Item Name: Crosstube Turning Detail

DART AEROSPACE LTD		Work Order:	96406
Description: Crosstube Assembly (412 High Aft)		Part Number:	D412-664-243
Inspection Dwg: D412-664-243 Rev: E		Page 1 of 2

DRAWING NO. D412-664-243	TITLE CROSSTUBE ASSEMBLY (412 HI AFT)	REV. E	DART AEROSPACE LTD ENGINEERING ORDER		D.E.O. NO. D412-664-243-E-1	SHEET NO. SHEET 1 OF 2	SCALE NTS
DRAWN	CHECKED	MFG. APPR.	APPROVED	DE APPR.			
DATE 11.03.31	DATE 11/03/31	DATE 11.03.31	DATE 11/03/31	DATE 11.03.31

**D412-664-243
ASSEMBLY DETAIL**

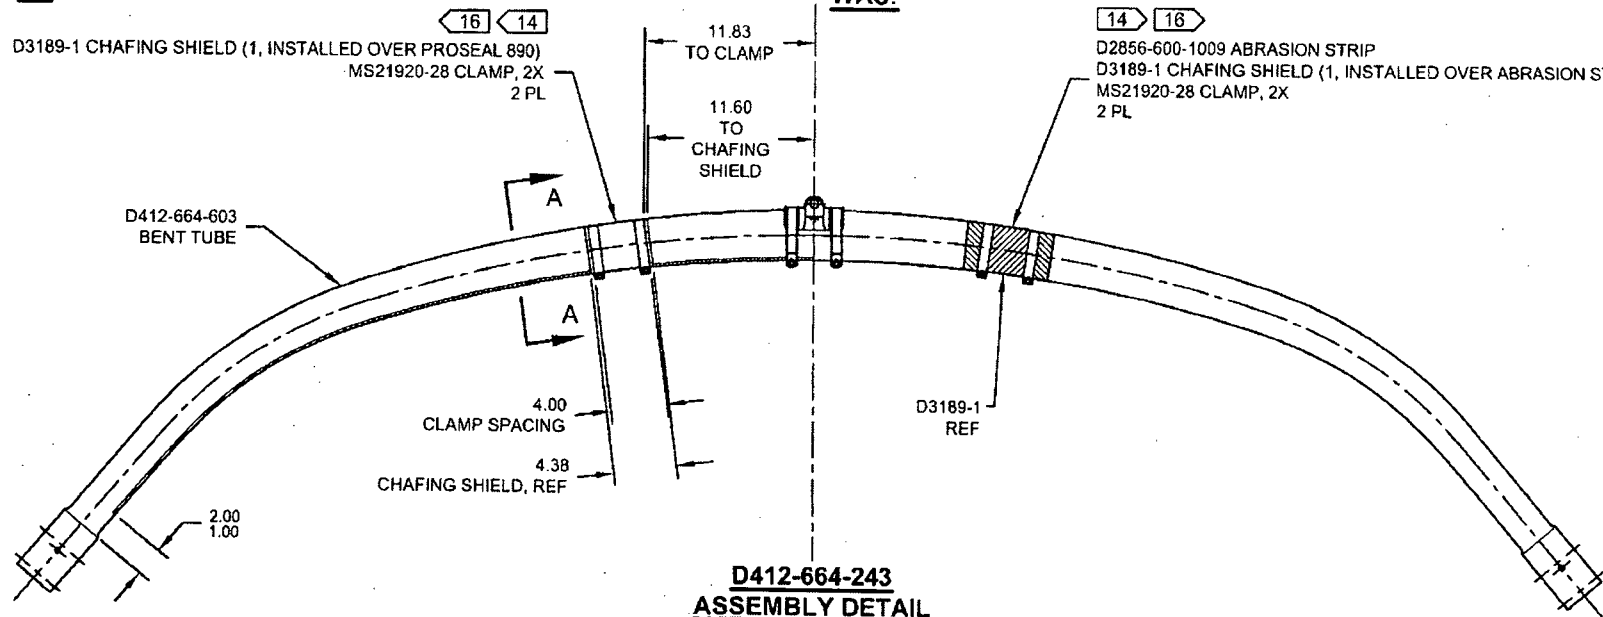
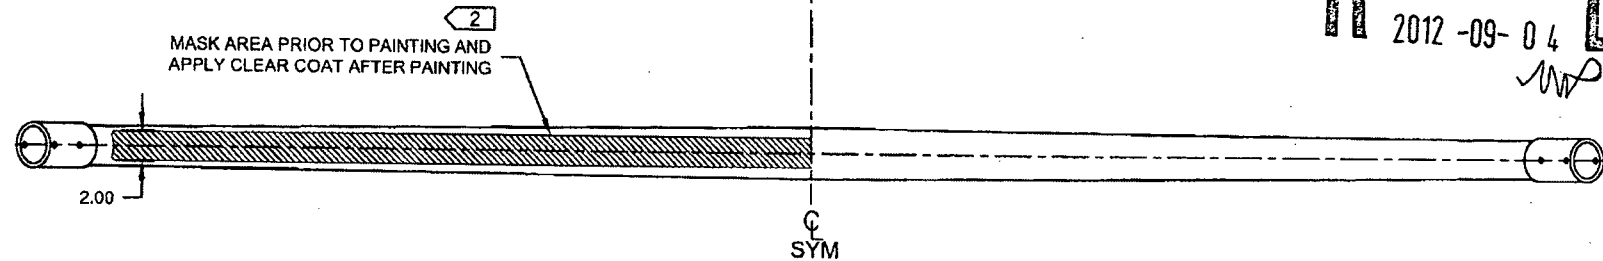
REMOVED ABRASION STRIP IN FAVOR OF A THIN LAYER OF PROSEAL 890. UPDATE INSTALLATION OF CHAFING SHIELDS AND REDUCE TORQUE TO 40-50 IN-LBS. THIS ENGINEERING ORDER SUPERCEDES DEO D412-664-243-E-1.

D3189-1 CHAFING SHIELD (1, INSTALLED OVER PROSEAL 890)
MS21920-28 CLAMP, 2X
2 PL

D2856-600-1009 ABRASION STRIP
D3189-1 CHAFING SHIELD (1, INSTALLED OVER ABRASION STRIP)
MS21920-28 CLAMP, 2X
2 PL

SECTION A-A
CHAFING SHIELD DETAIL
VIEW ROTATED, NOT TO SCALE

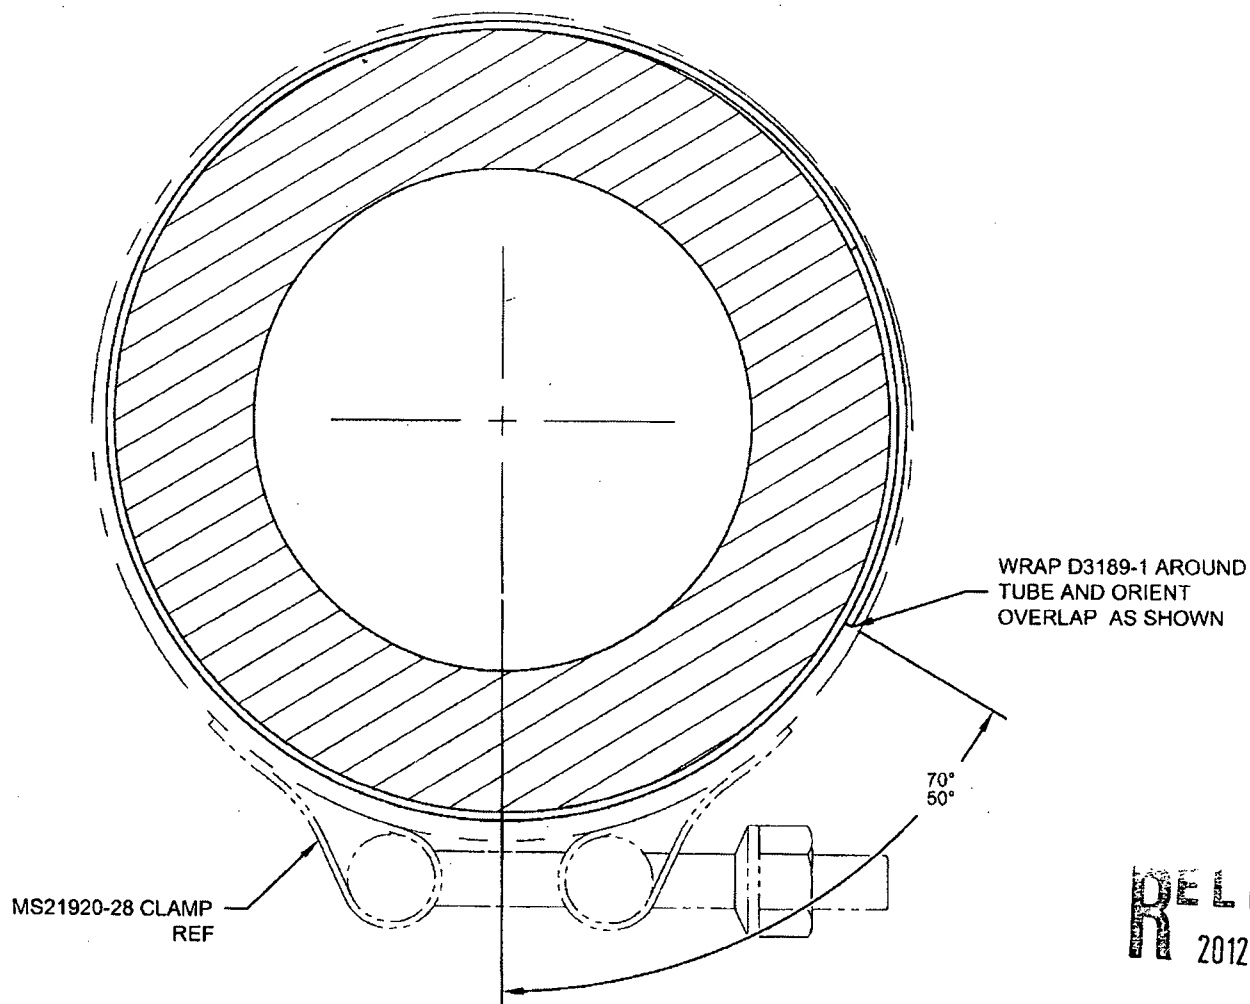
- 2) FINISH: CHEMICAL CONVERSION COAT PER DART QSI 005 4.1
PRIME INSIDE AND OUTSIDE PER DART QSI 005 4.2
MASK UNDERSIDE OF CROSSTUBE AS SHOWN (HATCHED AREA)
PAINT OUTSIDE PER DART QSI 005 4.2
AFTER PAINTING, APPLY CLEAR COAT ON HATCHED AREA
- 14) APPLY A THIN COAT OF PROSEAL 890 ON INSIDE CONCAVE SURFACE OF D3189-1 CHAFING SHIELD AND LET CURE PER MANUFACTURER'S INSTRUCTIONS. INSTALL PROSEALED D3189-1 CHAFING SHIELD ONTO CROSSTUBE BY APPLYING A THIN COAT OF PROSEAL 890 ONTO CROSSTUBE. BE SURE TO ELIMINATE ANY AIR GAPS.
- 16) TORQUE CLAMPS ON D2896-1 SUPPORT 80 TO 100 IN-LB. **TORQUE CLAMPS ON D3189-1 CHAFING SHIELD 40 TO 50 IN-LB.**
ENSURE AT LEAST 1.5 THREADS SHOWING IN SAFETY AND THAT NUT HAS NOT BOTTOMED-OUT AFTER TORQUING.
